International Isotopes Inc.

Subject: Submittal of Responses to Requests for Additional Information (RAI) TAC L32739.

The following enclosures are provided as a response to the US Nuclear Regulatory Commission RAIs pertaining to the International Isotopes Fluorine Products Inc. December 30, 2009 application to license a depleted uranium hexafluoride de-conversion and fluorine extraction process facility.

Official Responses to Seismic and Structural RAIs

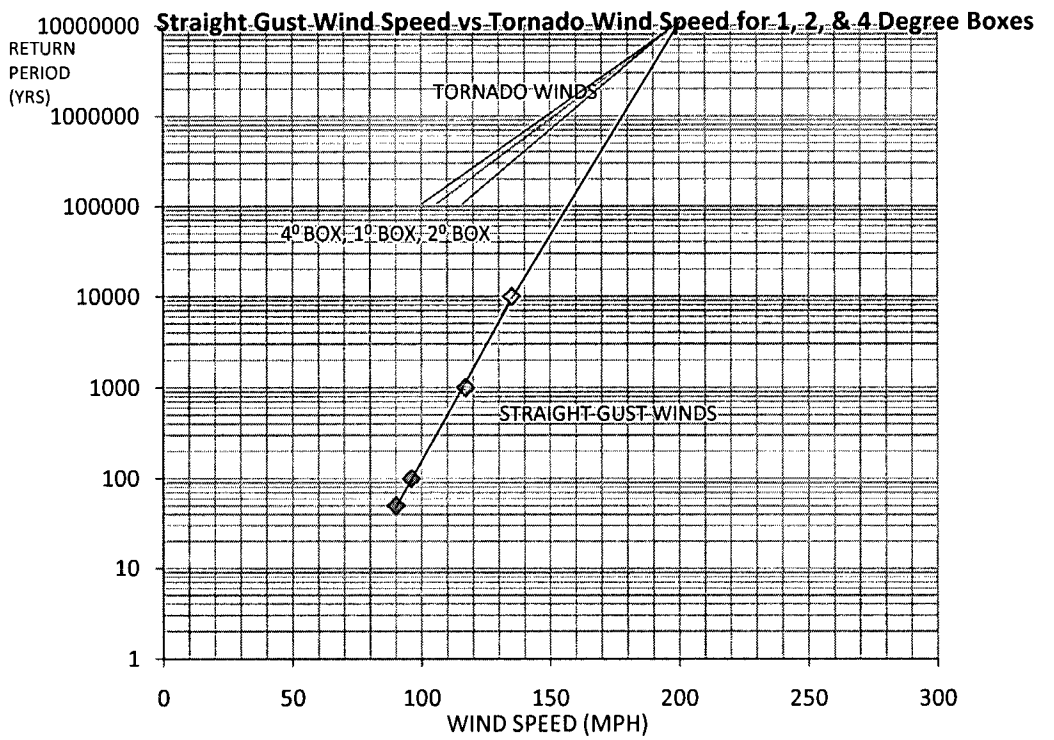
provides calculations based upon 46,800 tornado segments occurring from January 1, 1950 through August, 2003 of which more than 39,600 had sufficient information on location, intensity, length, and width to be used in the analysis included in this report. NUREG/CR-4461, Revision 1 had been published in April 2005. The National Weather Service changed from using the Fujita Scale to the Enhanced Fujita Scale in February 2007. Revision 2 incorporates the Enhanced Fujita Scale in its methodology and calculations. Specifically, Chapter 5 of the NUREG has been revised to show $1x10^{-5}$, $1x10^{-6}$, and $1x10^{-7}$ probability design wind speeds (i.e., probability of exceeding that wind speed in one year) for the contiguous United States estimated using the above database and the Enhanced Fujita Scale. (NCDC, 2010b)
The two-degree box where the IIFP site is located is in Region 2. While the two-degree and four-degree boxes are considered to be more reliable since they contain data for more events, the document does allow the use of the one-degree data if the number of events is large enough to provide accurate calculations. Instructions for using the NUREG Appendix C, Results for one-degree boxes state that the data set should contain a minimum of 10 events with 20 or more events being desirable. There were 76 events reported for the one degree box whose SE corner is the $32^0/103^0$ gridline. Of these, 56 were used in the calculations. The four-degree box uses data from 364 events of the 435 events observed.

The data from the above NUREG appendices for the one-degree, two-degree, and four-degree boxes are used. The maximum tornado wind speeds versus return period for each box are plotted on the same chart with the straight gust wind speed data (DOE-1020-2002, Table 3-2) versus return period for sites with basic gust wind speed of 90 mph (per USGS maps as adopted by the model building codes). All three tornado wind speed curves intersect the straight gust wind speed curve at approximately a 1×10^7 year return period or a probability of exceeding of 1×10^{-7}. DOE-STD-1022-2002, Appendix D, Paragraph D.2 states that, generally, straight and hurricane winds control the criteria for probabilities down to about 10^{-4}. Therefore, straight gust wind speeds will be used as the wind design basis for building design at the IIFP Facility.

Legend: 4° Box - Red; 1° Box - Green; 2° Box - Blue

Note: See the discussion of straight winds below for the derivation of basic gust wind speeds versus probability used in the plots discussed above.
